E1100044-v1

Advanced LIGO I & Q RF Demodulator (2 channel version)

Design document

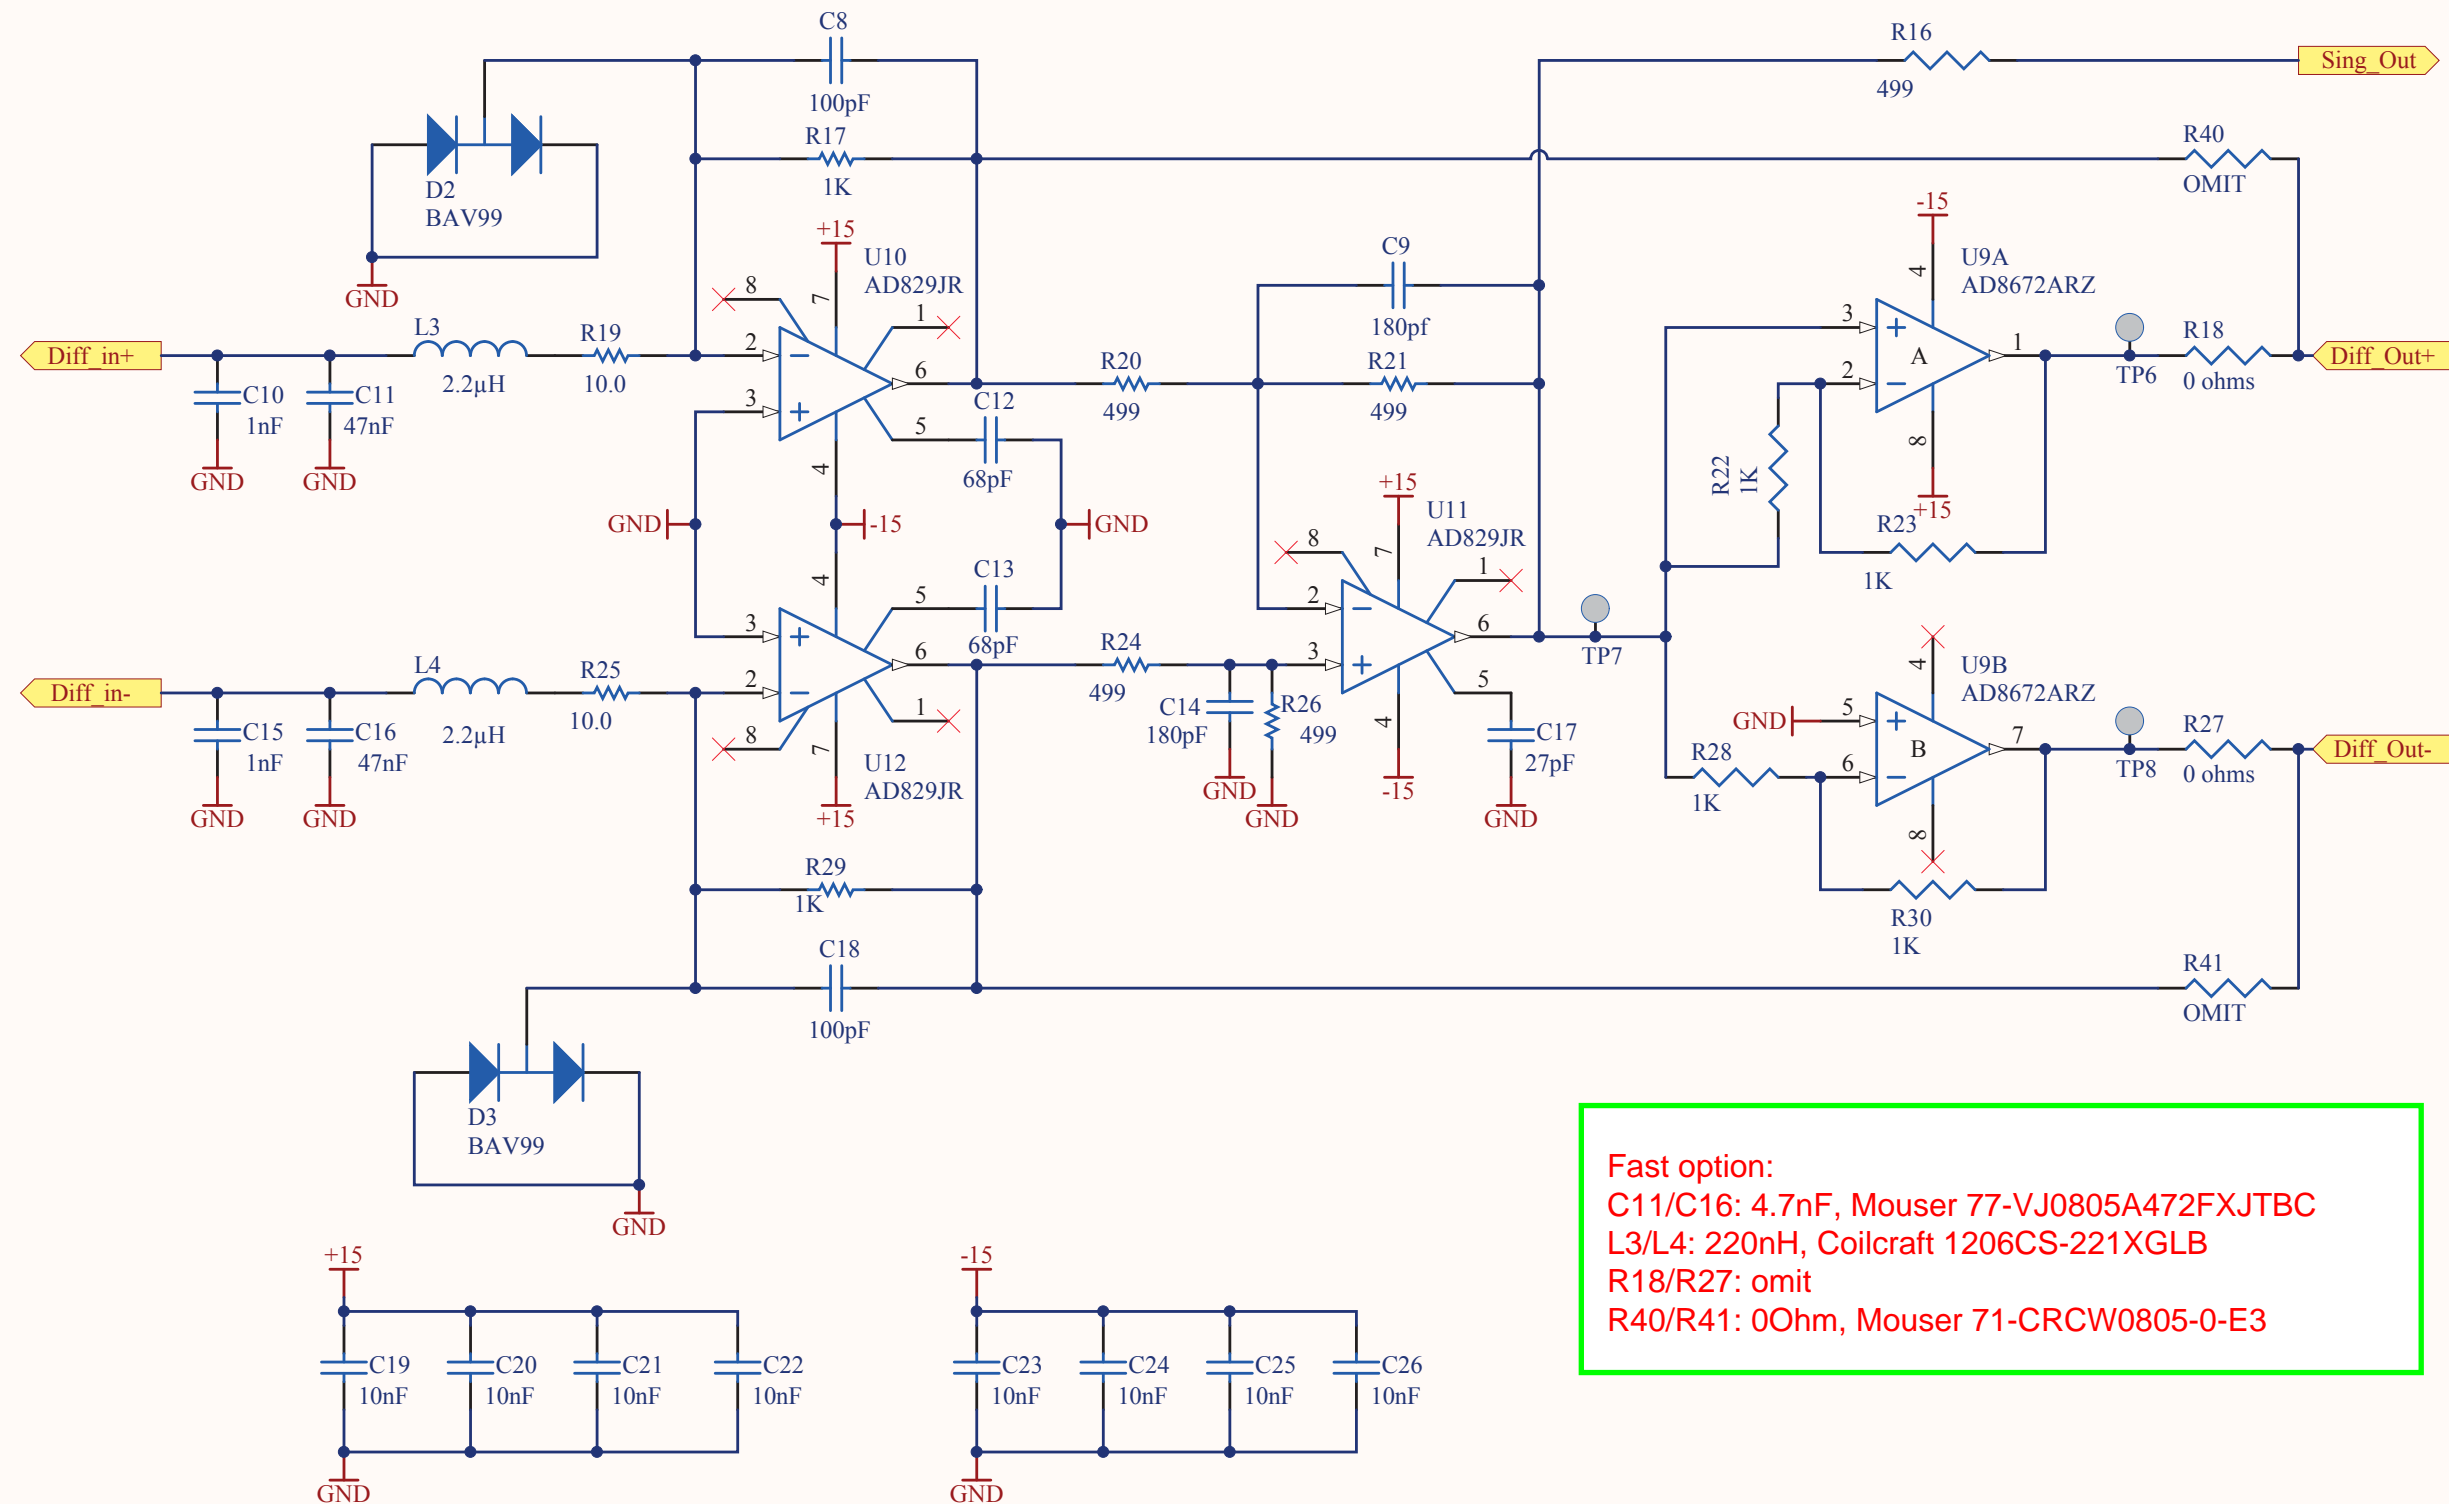
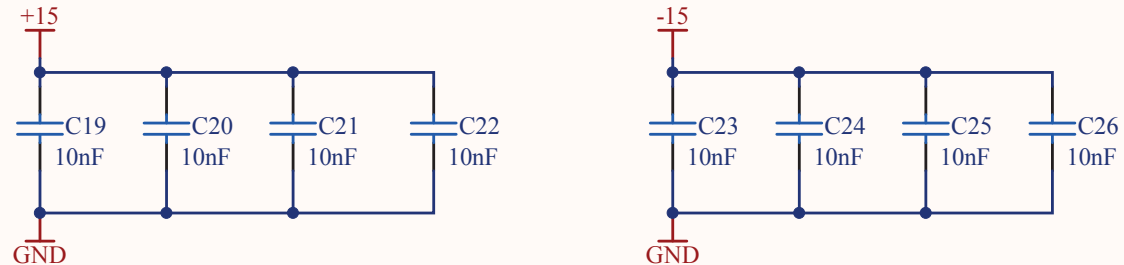
Fast option:
 C11/C16: 4.7nF, Mouser 77-VJ0805A472FXJTBC
 L3/L4: 220nH, Coilcraft 1206CS-221XGLB
 R18/R27: omit
 R40/R41: 0Ohm, Mouser 71-CRCW0805-0-E3
